MCC Addendum #2 Narrative
10/18/24

Sunman-Dearborn Community Schools – BP#2

ADDENDUM #2

October 18, 2024

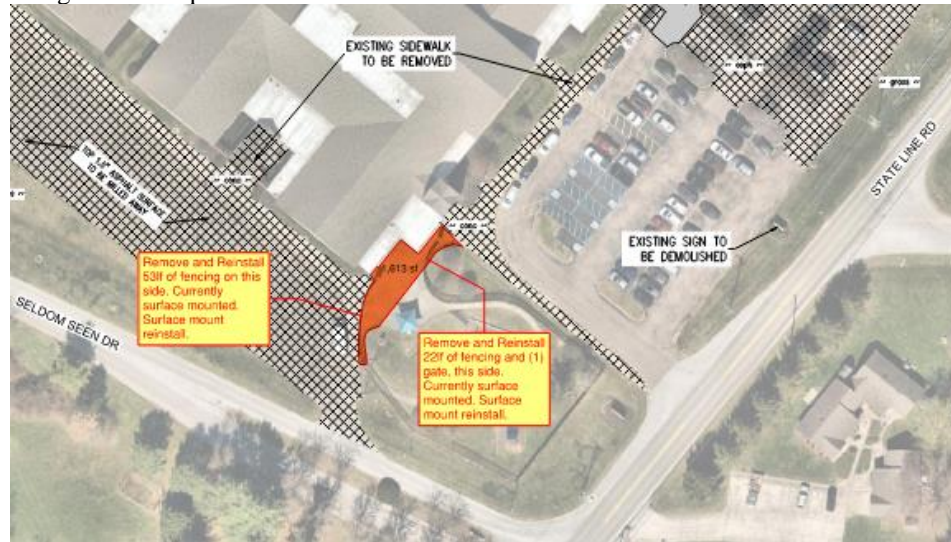
- **Q:** Who is responsible for demo and moving the Fire Suppression Drain Down Line in the ECHS Boiler Room per Note 7 on MD104 and Note 9 on MP304?

- **A:** BC-2 General Trades Fire Suppression Subcontractor to be responsible for demo and replacement of this line.
- **Q:** Spec section 00 31 13.1 calls for 6 relief fans to be installed. Neither the mechanical drawings nor the schedules show these fans. Please clarify what manufacturer, model number for the BOD and an associated spec for these fans as well as where these fans will be located on the building.

Alternate No. 5B – BES – ADA Synthetic Playground Turf – Access Wedges

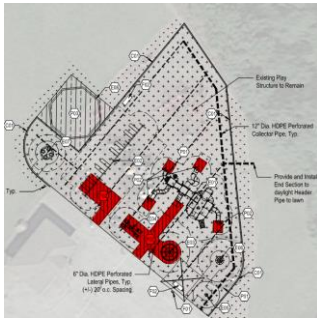
- Base bid Description: Base bid to include P01 Engineered Wood Fiber at full playground area at BES.
- Alternate #5B Description: to include ADD for Synthetic Playground Turf at ADA P02 P.I.P Access Wedge in areas as indicated at the BES Playground per Sheet L101. Alternate to include Synthetic Playground Turf per added spec section 321818 Playground Synthetic Turf in ADA Access Wedges referenced to receive alternate surfacing P02. Bidders shall account for ALL COST IMPACTS to coordinate and adjust profiles, excavation, subgrade elevations, padding, drainage, aggregate base, etc needed for a turn-key playground turf system. The price presented shall represent the differential cost between the original design of Engineered Hardwood and the alternate turf system at the ADA Access Wedges as listed.

Alternate No. 4 – ECHS Media Center Casework – Replacement of Fixed Bookshelves w/ new P-Lam Units.

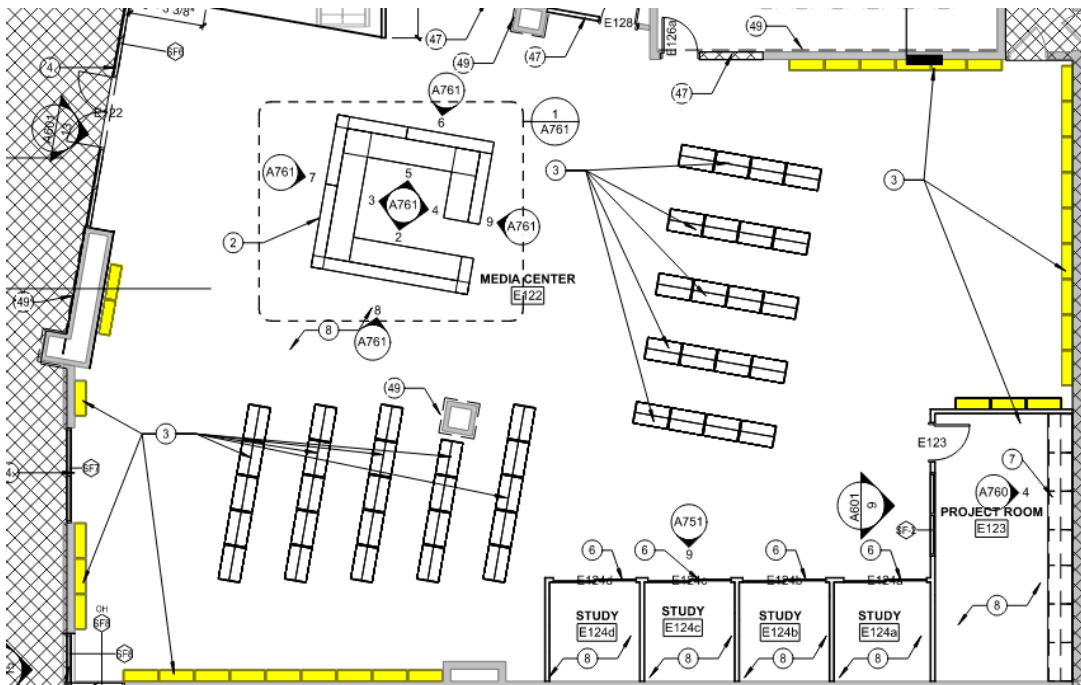
- **Alternate #4 Description:** to include **ADD** for supplying and installing new fixed casework at perimeter walls at ECHS Media Center for perimeter casework with Note 3 on Sheet A101H as highlighted in yellow below. Contractor to disregard reinstallation of existing casework but units are to still be disassembled with care and stored onsite. Owner would like to have the ability to use casework in other spaces. Clarification and revised drawings for Alternate 4 to be provided in fourth coming Addendum.

- **Base bid Description:** For casework noted by Note 20 on Sheet AD101H, contractor to disregard note and instead include piece-by-piece disassembly/ removal of the ECHS Media Center Casework and once disassembled, include moving pieces elsewhere onsite for storage. Contractor to clearly mark unit numbers on casework and be responsible for relocating and reassembling units prior to flooring being installed in space.

Alternate No. 5A – BES – ADA P.I.P Access Wedges

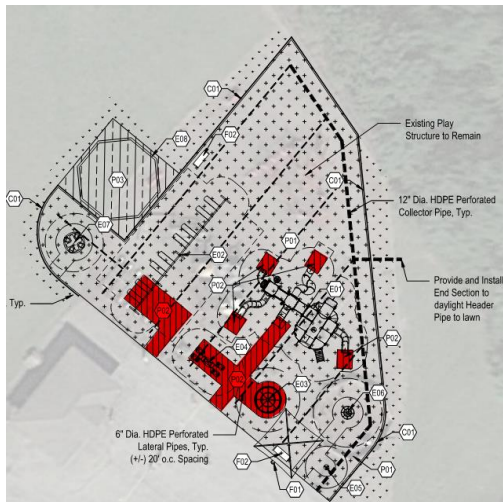
- **Base bid Description:** Base bid to include P01 Engineered Wood Fiber at full playground area at BES.
- **Alternate #5A Description:** to include ADD for ADA P02 P.I.P Access Wedge in areas as indicated at the BES Playground per Sheet L101 and Details on Sheet L600.
